Access Compliance Report

Public Rights-of-Way

(Curb Ramps)

Intersection ID: 30305	Main Street: GALLATIN_LN	Cross Street: RAVANNA_DR	Location:	N
ADA ID: A35A95C58758	Ramp Type: BlendTrans1	Initial Pass/Fail: Fail	Overall Compliance: No	Severity Score: 35
Codes/Mitigation Info/Possible Solution		Field Measurements/Component Compliance

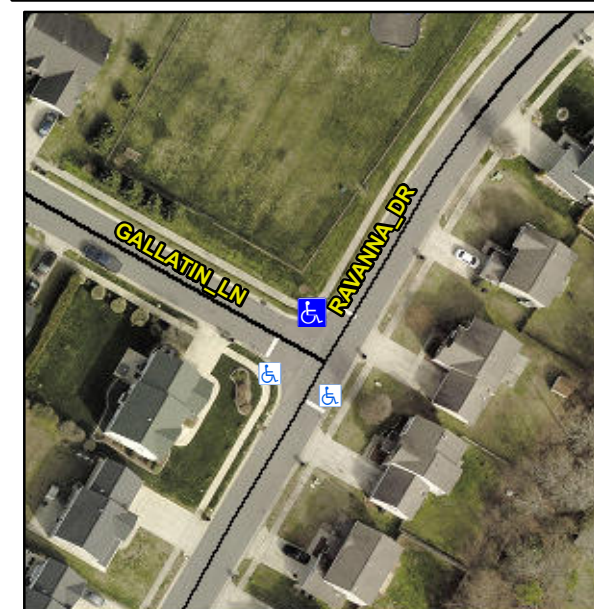
Not Found, R304.5.1

Compliance	Description	Data	Compliance	Description	Data
N/A	Ramp Length (in)	51.0	Yes	BlendTrans Slope (%)	4.1
No	Ramp Width (in)	28.0	Yes	BlendTrans XSlope (%)	1.1
N/A	Flare Type LT	N/A	N/A	Flare Type RT	N/A
N/A	Flare Slope LT (%)	N/A	N/A	Flare Slope RT (%)	N/A
N/A	Flare Traversable LT?	N/A	N/A	Flare Traversable RT?	N/A
N/A	Landing Length (in)	N/A	N/A	DWS Provided?	N/A
N/A	Landing Width (in)	N/A	N/A	DWS Contrast?	N/A
N/A	Landing Slope (%)	N/A	N/A	DWS Length (in)	N/A
N/A	Landing X Slope (%)	N/A	N/A	DWS Full Width?	N/A
N/A	Landing Curb? (Y/N)	N/A	N/A	DWS Offset (in)	N/A
N/A	Shared Landing?	N/A			
N/A	Gutter Ponding?	N/A	N/A	Gutter Slope (%)	N/A
N/A	Gutter Lip Ht (in)	1.0	N/A	Gutter X Slope (%)	N/A
N/A	Painted X Walk1?	No	N/A	Painted X Walk2?	No
	X Walk 1 Direction	To SW		X Walk 2 Direction	To SE
	X Walk 1 Width (in)	N/A		X Walk 2 Width (in)	N/A
	X Walk 1 Slope (%)	2.3		X Walk 2 Slope (%)	0.8
	X Walk 1 X Slope (%)	1.1		X Walk 2 X Slope (%)	2.1

N/A	Ramp inside XWalk1?	N/A	N/A	Ramp inside XWalk2?	N/A
	Road Slope (%)	1.0		Clear Space?	N/A
	Road X Slope (%)	2.0	N/A	Clear Space to XWalk (in)	N/A
N/A	Any Obstructions?	N/A	N/A	Storm Grate/Utility Hazard?	N/A
	Obstruction Type			Storm Grate/Utility Type	
		N/A			N/A
			Yes	Surface Condition? (G/P)	Good
			No	Curb Slope (%)	12.1

Remove & Replace Curb Ramp With Two New Directional Ramps or Equivalent.
